Access Compliance Report

Public Rights-of-Way

(Curb Ramps)

Intersection ID: 10025885	Main Street: ELIZABETH_AV	Cross Street: N/A	Location: N
ADA ID: A06220B2448E	Ramp Type: Perp	Initial Pass/Fail: Pass	Overall Compliance: No
			Severity Score: 2.75
Codes/Mitigation Info/Possible Solution		Field Measurements/Component Compliance

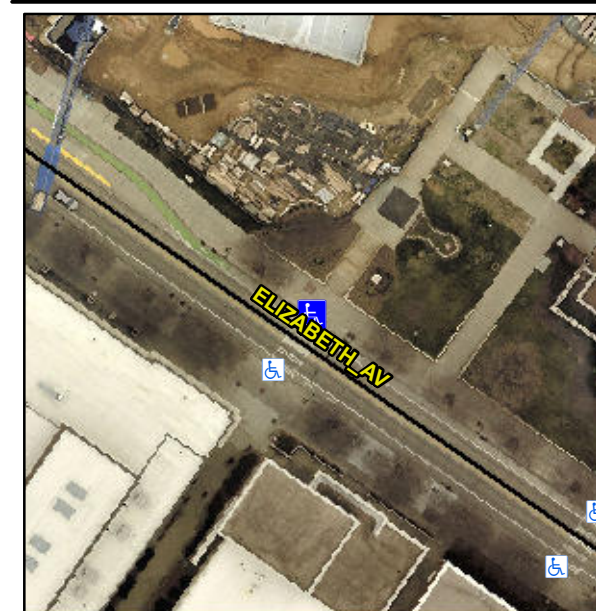
Not Found, R304.2.3, R304.5.3

Compliance	Description	Data	Compliance	Description	Data
N/A	Ramp Length (in)	84.0	Yes	Ramp Slope (%)	5.9
Yes	Ramp Width (in)	96.0	Yes	Ramp XSlope (%)	4.1
N/A	Flare Type LT	Sloped	N/A	Flare Type RT	N/A
N/A	Flare Slope LT (%)	0.8	No	Flare Slope RT (%)	10.4
N/A	Flare Traversable LT?	Yes	N/A	Flare Traversable RT?	Yes
Yes	Landing Length (in)	60.0	Yes	DWS Provided?	Yes
Yes	Landing Width (in)	96.0	Yes	DWS Contrast?	Yes
Yes	Landing Slope (%)	0.9	Yes	DWS Length (in)	24.0
Yes	Landing X Slope (%)	3.6	Yes	DWS Full Width?	Yes
N/A	Landing Curb? (Y/N)	No	Yes	DWS Offset (in)	0.0
N/A	Shared Landing?	No			
Yes	Gutter Ponding?	No	Yes	Gutter Slope (%)	0.1
Yes	Gutter Lip Ht (in)	0.0	No	Gutter X Slope (%)	4.2
N/A	Painted X Walk1?	Yes	N/A	Painted X Walk2?	N/A
	X Walk 1 Direction	To SW		X Walk 2 Direction	N/A
N/A	X Walk 1 Width (in)	140.0	N/A	X Walk 2 Width (in)	N/A
	X Walk 1 Slope (%)	1.1		X Walk 2 Slope (%)	N/A
	X Walk 1 X Slope (%)	4.1		X Walk 2 X Slope (%)	N/A

**Remove & Replace Entire Ramp.
Remove & Replace Gutter.**
